KAFB 95
DEPARTMENT OF THE AIR FORCE
HEADQUARTERS 377TH AIR BASE WING (AFMC)
CERTIFIED MAIL: Z 106 120 491
RETURN RECEIPT REQUESTED

KAFB is in receipt of your 14 Jun 1995, letter concerning our proposed sampling and analysis plan for SWMU RW-68, Radium Dump/Slag Piles, and the following information is submitted in response to your questions:

RW-68 SAMPLING AND ANALYSIS PLAN

FIGURE 1

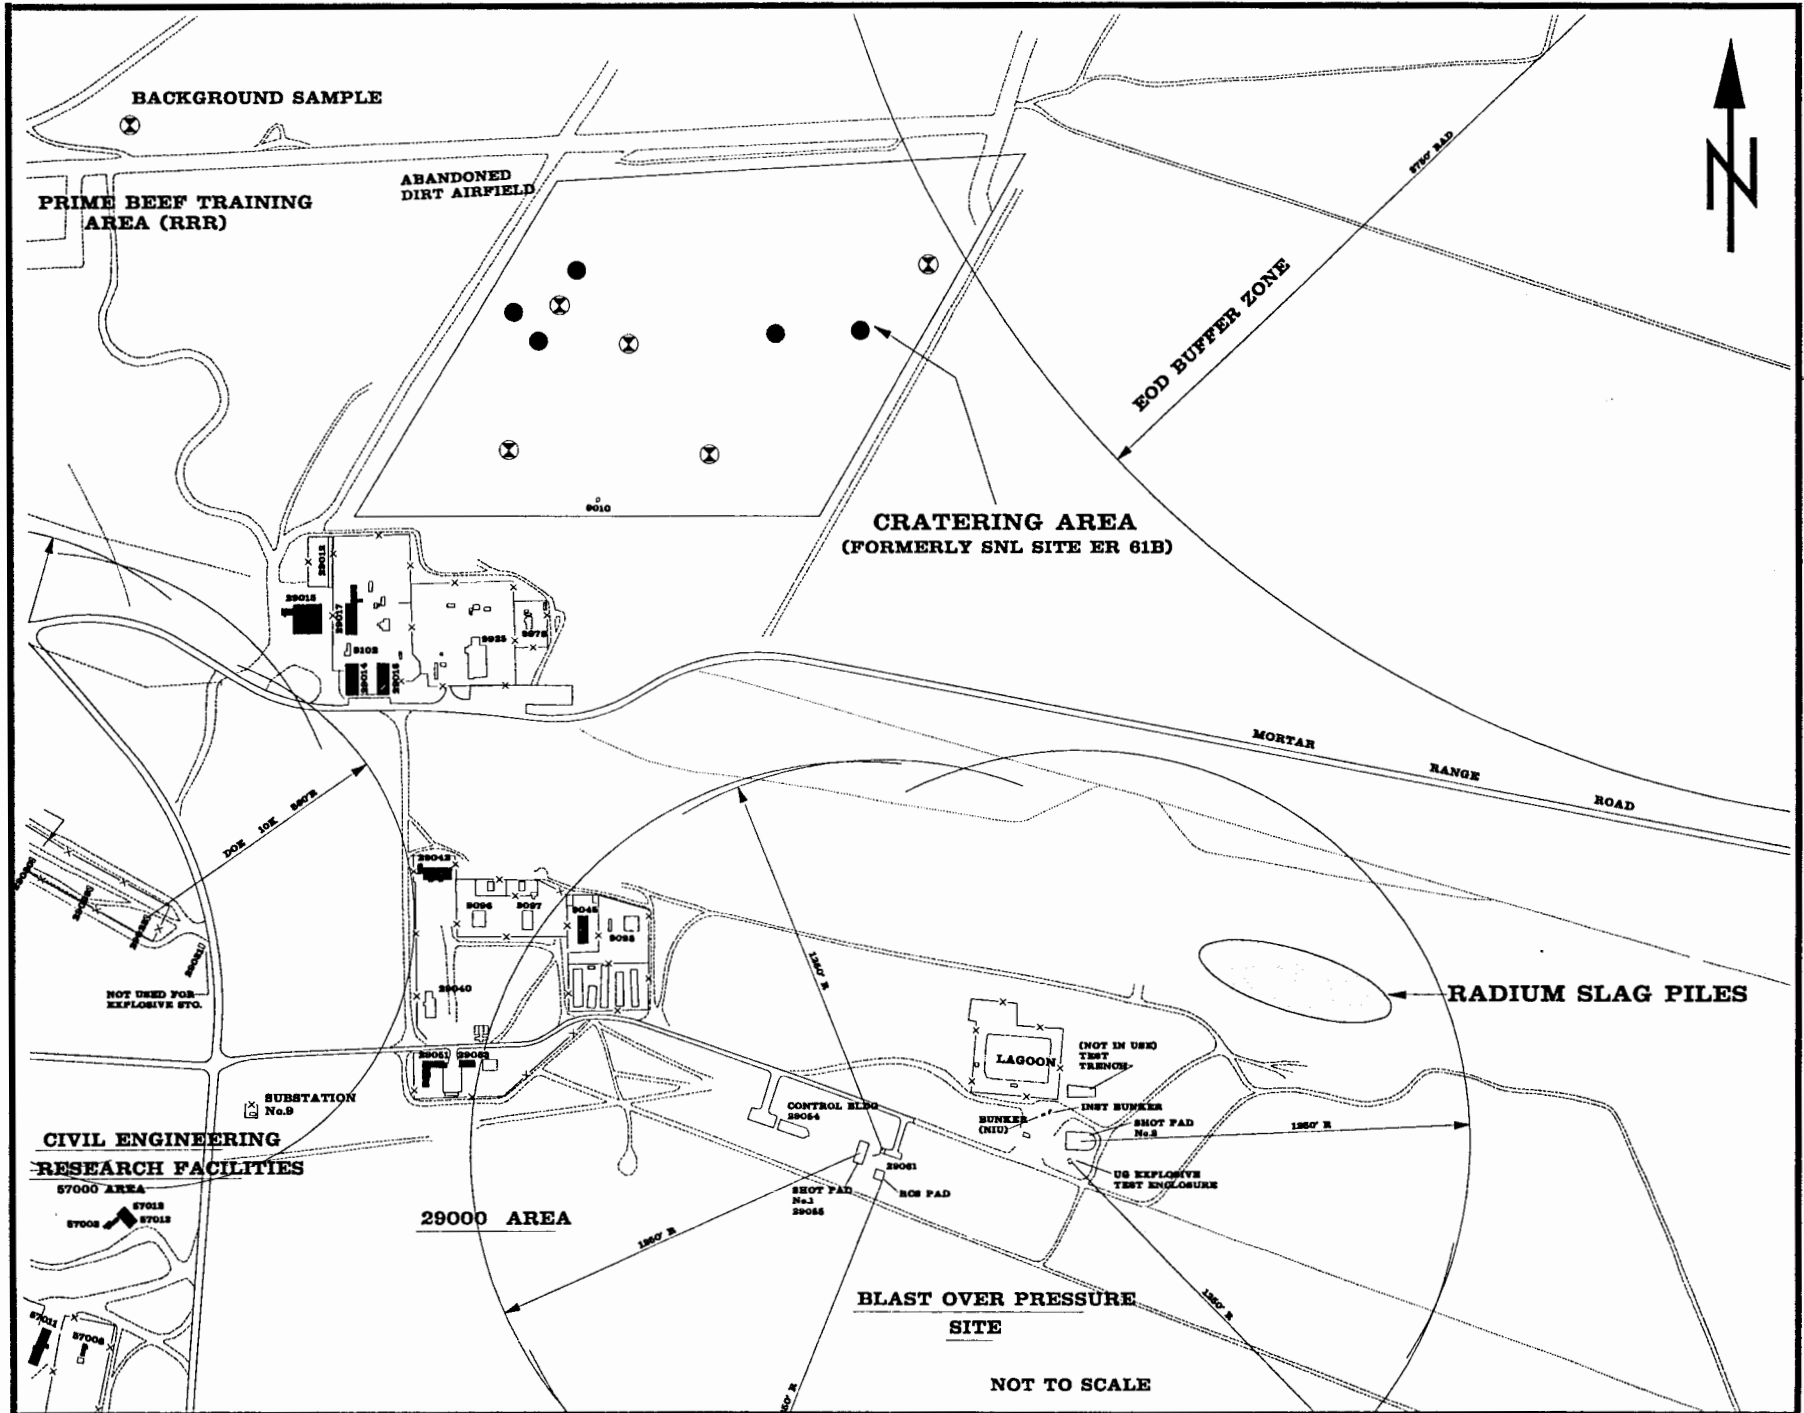
1. Although the site is approximately 42 acres in size, the nature of the activities were such that a substantial clear zone was probably necessary, so a majority of the area was not used to conduct explosives studies. The term "Cratering Area" is somewhat misleading because craters are not readily observed. However, there are scattered sites where the soil looks disturbed, small blast holes (6 in. diameter) are recognizable, and tumbleweeds are in abundance. According to our contractor, tumbleweeds flourish in areas of soil disturbance. Therefore, because of the lack of distinguishable craters in the area, sample locations were selected primarily on the basis of soil disturbance and tumbleweed growth patterns. At one site selected for sampling, disturbed soil, tumbleweeds, and blasting caps with primer cord were observed. Blasting materials were not noted at any other site in the Cratering Area. Small detonation areas are up to 10 ft in diameter while large detonation areas are 10 - 20 ft in diameter. Sampling locations are depicted on Figure 1.
